PWROG-16043-NP-A Revision 2

PWROG PROGRAM TO ADDRESS NRC INFORMATION NOTICE 2012-09: "IRRADIATION EFFECTS ON FUEL ASSEMBLY SPACER GRID CRUSH STRENGTH" FOR WESTINGHOUSE AND CE PWR FUEL DESIGNS

**U.S. Nuclear Regulatory Commission
Comment Resolution Table for PWROG-16043**

Figure 4. Example of Grid Impact

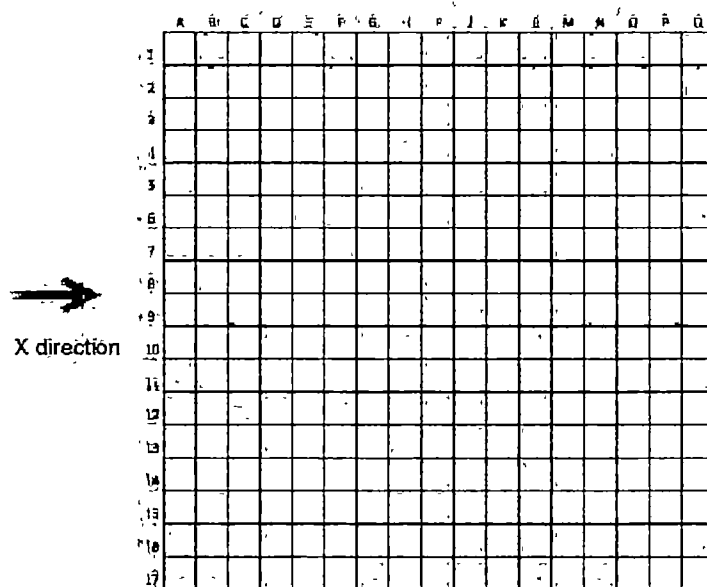
b. "how this may impact the spacer grid structural behavior"

The grid impact occurs on the grid side surfaces. For example, a grid is impacted in the X direction as shown in Figure 4. The impact force is shared by the whole column A (from cell A1 to cell A17) and is transferred to the whole grid through all columns (from Column A to Column Q). Therefore, the cell gap size differences in a grid would have a small impact on the overall structural behavior of a spacer grid.
